To: T10 Committee (SCSI)

From: George Penokie (IBM/Tivoli)

Subject: SAS UML Corrections

Figure 15 — State machine and expander device, expander port, and expander phy classes

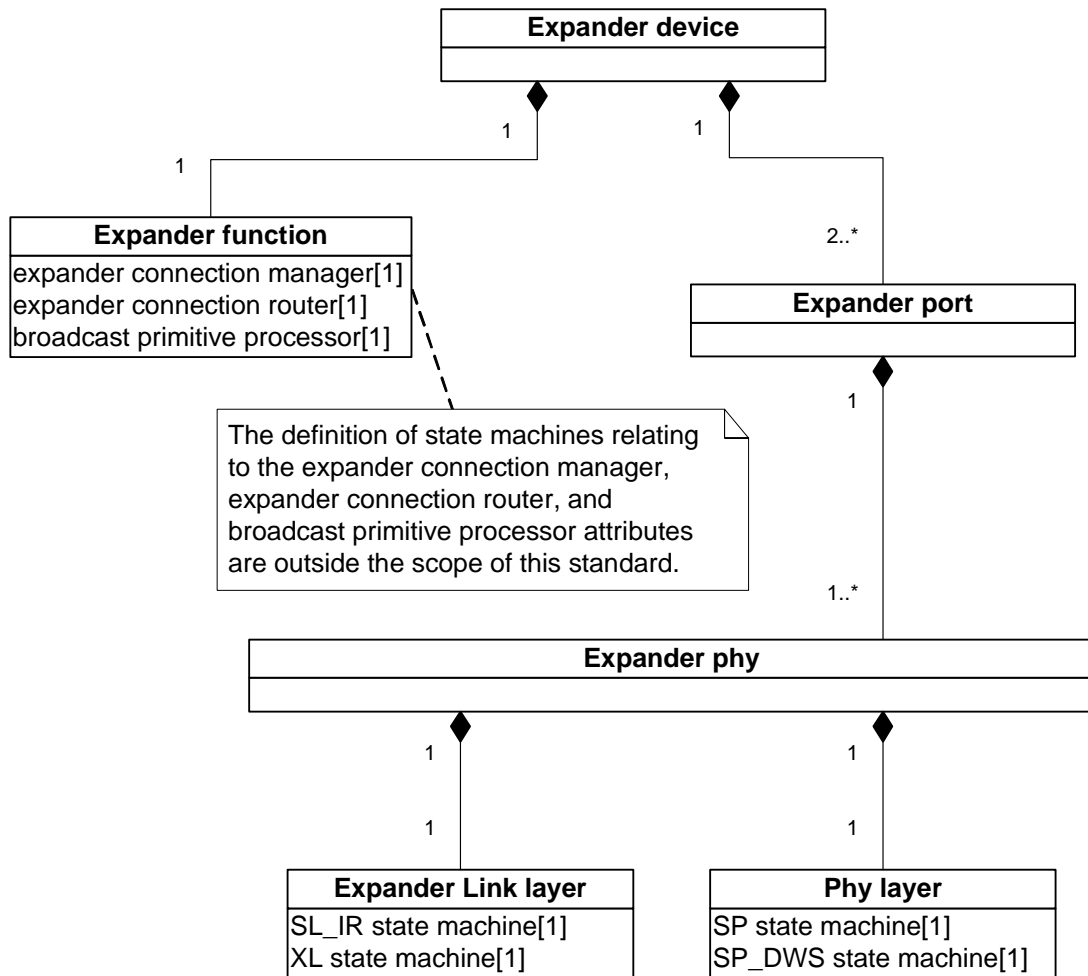
Figure 15 shows which state machines are contained within the expander device, expander port, and expander phy classes.
